# **HOLDOVER**

## **HIGHLAND PARK SUBDIVISION, RESUBDIVISION OF LOTS 21 & A PORTION OF LOT 22**

# HIGHLAND PARK SUBDIVISION, BLOCK 5, RESUBDIVISION OF LOTS 21 & A PORTION OF LOT 22

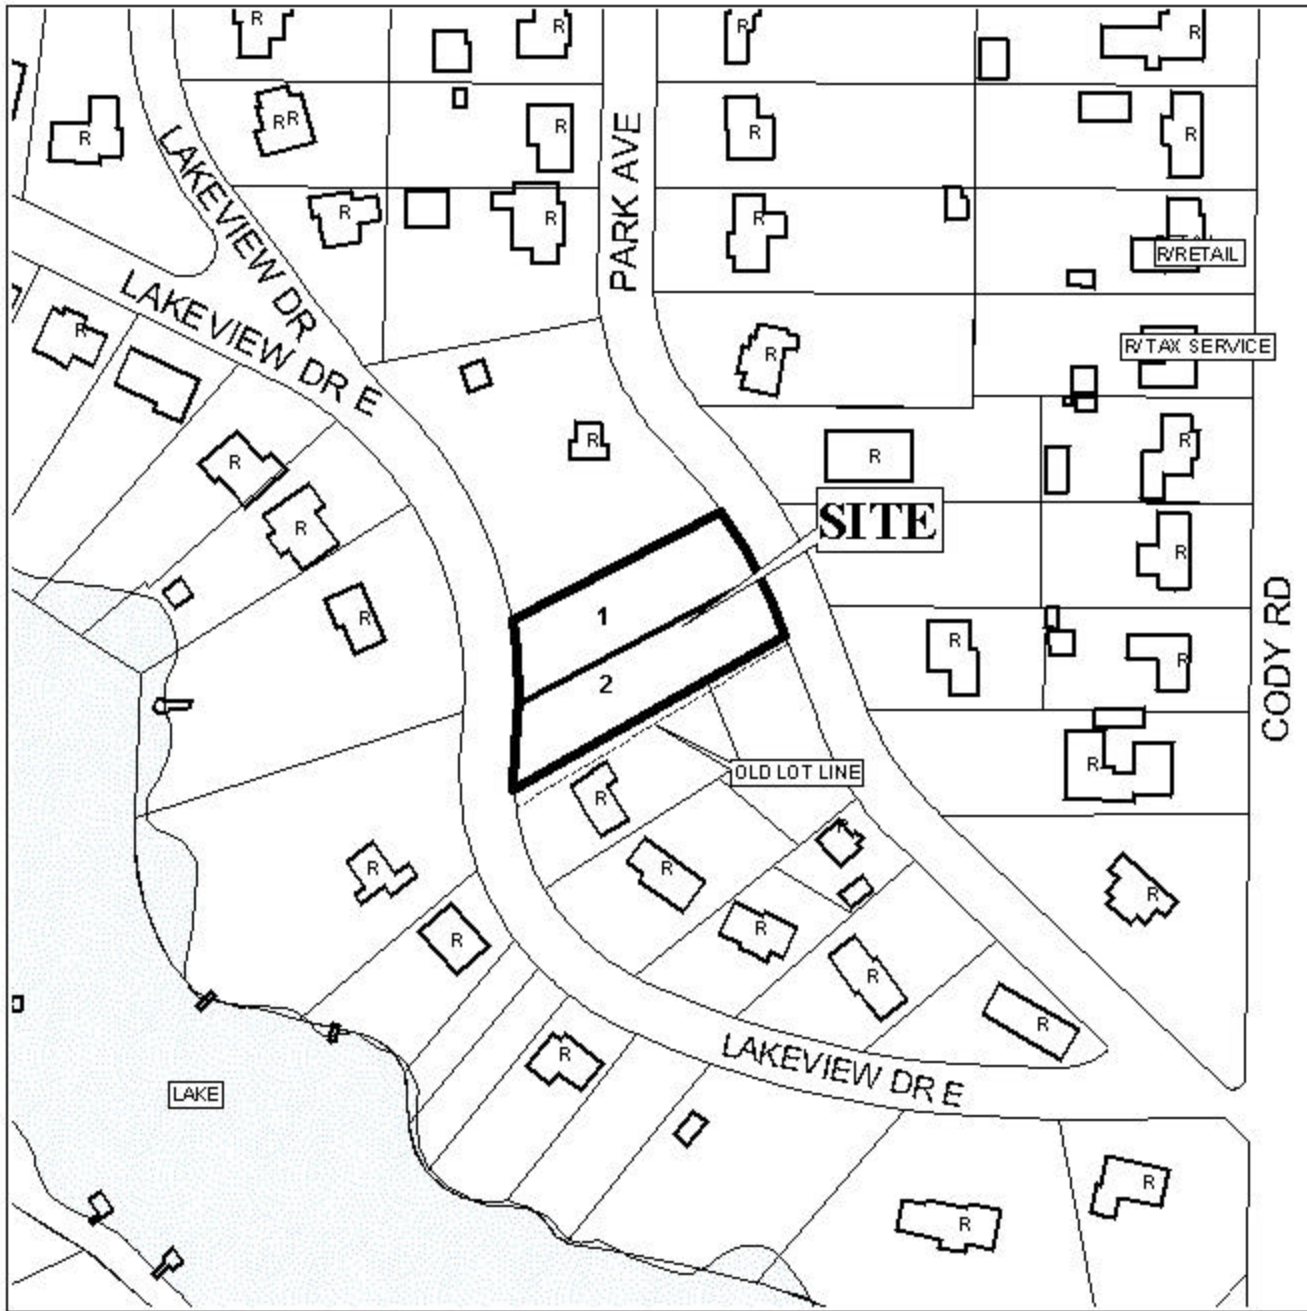
As illustrated on the site plan, the site will have frontage along two streets and there is a note on the final plat stating that the site is denied access to Park Avenue South.

As illustrated on the plat, the balance of Lot 22 is not included in the subdivision. The balance of Lot 22 should be included in the subdivision or the submission of documentation to establish the balance of Lot 22 as a legal lot of record prior to 1984 should be required.

This site is located in the County, thus a note should be placed on the final plat stating that any lots which are developed commercially and adjoin residentially developed property must provide a buffer in compliance with Section V.A.7., of the Subdivision Regulations.

Based upon the preceding, this application is recommended for holdover to allow the applicant to include the balance of the property in the subdivision with the additional notification, or to submit documentation to establish the balance of the property as a legal lot of record prior to 1952. This information should be submitted by July 14<sup>th</sup> to be considered at the Commission's July 24<sup>th</sup> meeting.
